**SUNDRY NOTICES AND REPORTS ON WELLS**  
*Do not use this form for proposals to drill or to re-enter an abandoned well. Use form 3160-3 (APD) for such proposals.*

8. Well Name and No.  
GULF FED COM 2

9. API Well No.  
30-015-20545-00-D1

Permanent Abandonment of Federal Wells  
Conditions of Approval

Cimarex Energy Co. of Colorado  
 Gulf Federal #2  
 1980' FSL & 990' FWL  
 Sec. 6, T-23-S, R-27-E, Eddy Co., NM  
 S. Gengler 05/15/2009

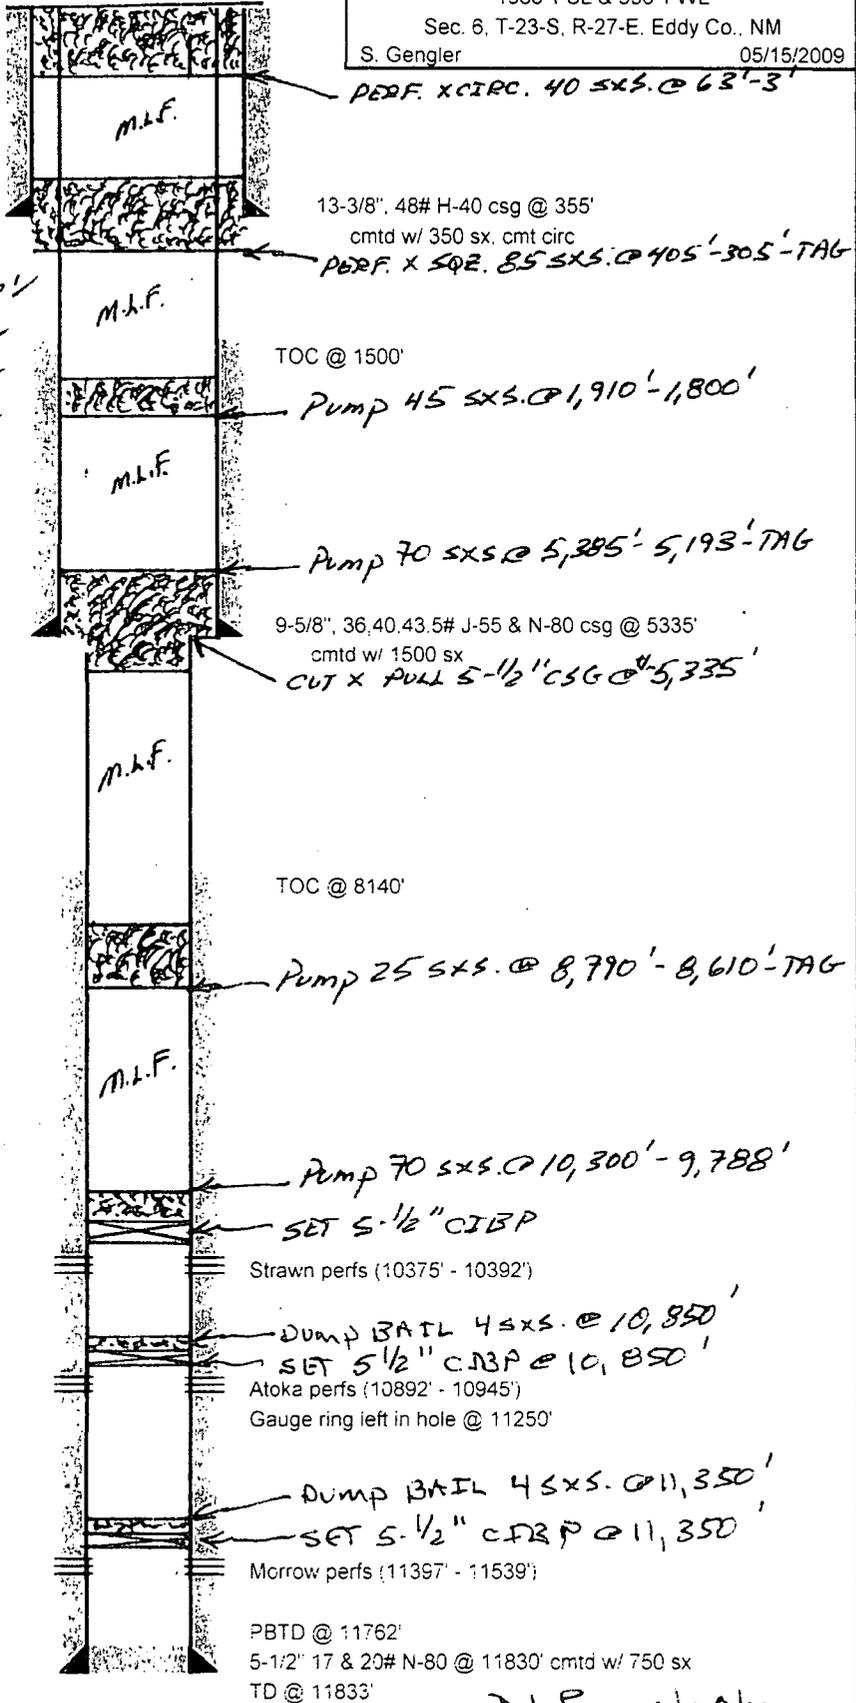
- 1) SET 5-1/2" CIBP @ 11,297; DUMP BAIL 4 SXS.CMT. @ 11,350' 11297 35' min dump bail.
  - 2) SET 5-1/2" CIBP @ 10,850'; DUMP BAIL 4 SXS.CMT. @ 10,850'.

- 5) CUT X PULL 5-1/2" CSG. @ +/-5,335' 5385
  - 6) PUMP 70 SXS.CMT. @ 5,385'-5,493'(5-1/2" CSG. CUT T/BNSG.); WOC X TAG CMT. PLUG. 5435-5193
  - 7) PUMP 45" SXS.CMT. @ 1,910'-1,800'(T/DLWR.). 1835 Add Plug, Perf @ 1145. SRZ cmt 10 1045. Tag
